SUBJECT: NRC COMMENTS ON TMI-2 PENETRATION R626 EXPERIMENT -
SAFETY EVALUATION REPORT

Procedure No./Title Safety Evaluation Report / Penetration R-26, Experiment

TMI-II CONTAINMENT SURVEILLANCE
SAFETY EVALUATION REPORT

SCHEMATIC OF BORING TOOLS

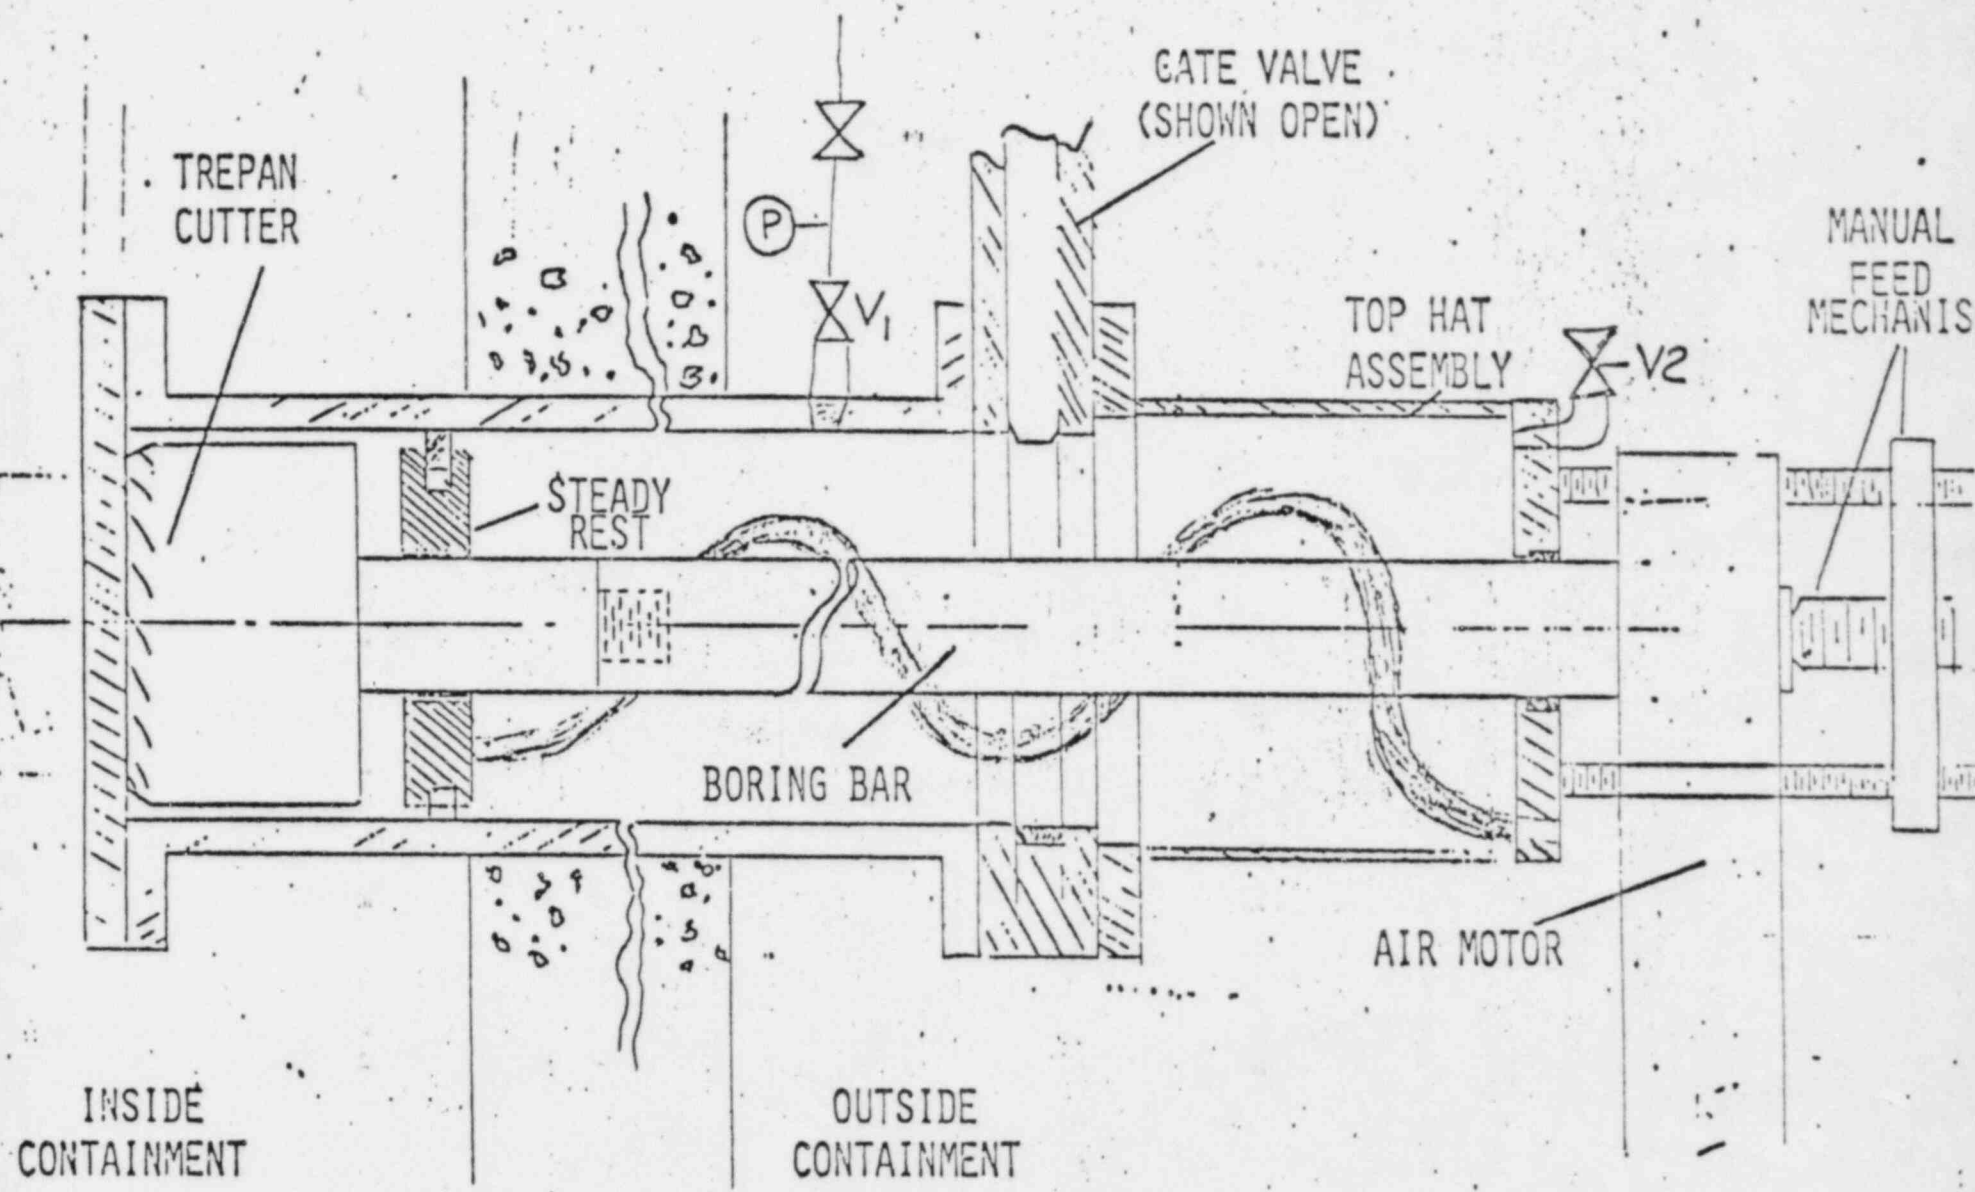
Para.	Comment	Resolution
General Safety Precautions	State the provision to monitor 1 CFM positive air flow into the containment when the isolation gate valves are opened.	
Phase I Hole Drilling	<p>You propose not to utilize glove box during hole drilling phase. We concur with you provided that (1) positive pressure will be maintained and monitored in top hat assembly throughout drilling operation and (2) positive air flow into the containment is also maintained and monitored during this operation.</p>	
	<p>Specify how you inspect for internal contamination through the removal of the pipe plug. Swiping techniques may provide better sensitivity for internal contamination.</p>	
	<p>Describe a rotary shaft seal on the bearing bar.</p>	
	<p>Working area plastic tent air should be monitored continuously during all modes of operation</p>

FIG. 6

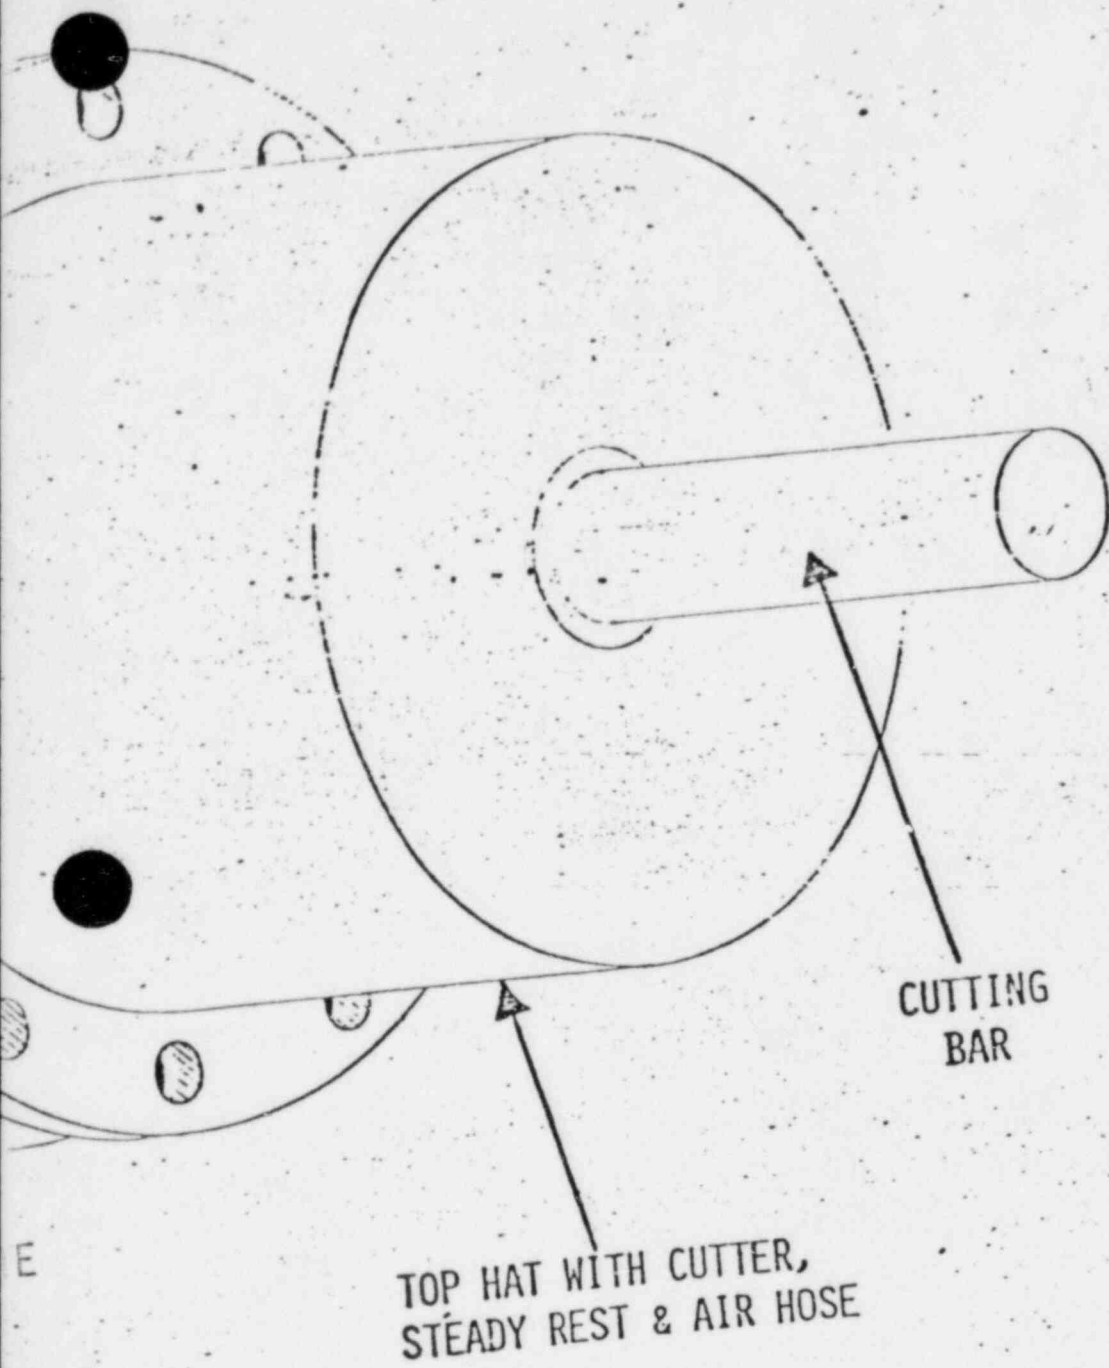
Para.	Comment	Resolution
	Approximately half of the core decay heat is transferred to the steam generators and the other half to water, walls, and floor at the present time	
Phase II Secondary Boundary Installation	Provide Burns & Roe reference on maximum allowable loads on penetration pipe.	
Phase III Containment Surveillance	In addition to mock-up tests performed at B & W, a complete rehearsal of step by step procedure at Penetration R-626 is desirable ^{essential} (except insertion of equipment).	
Figure 4	Gas sampling assembly complete with pump, filters, and tubing should be pressure tested.	Update drawing showing a pressure gauge and a valve in upstream of V-2.
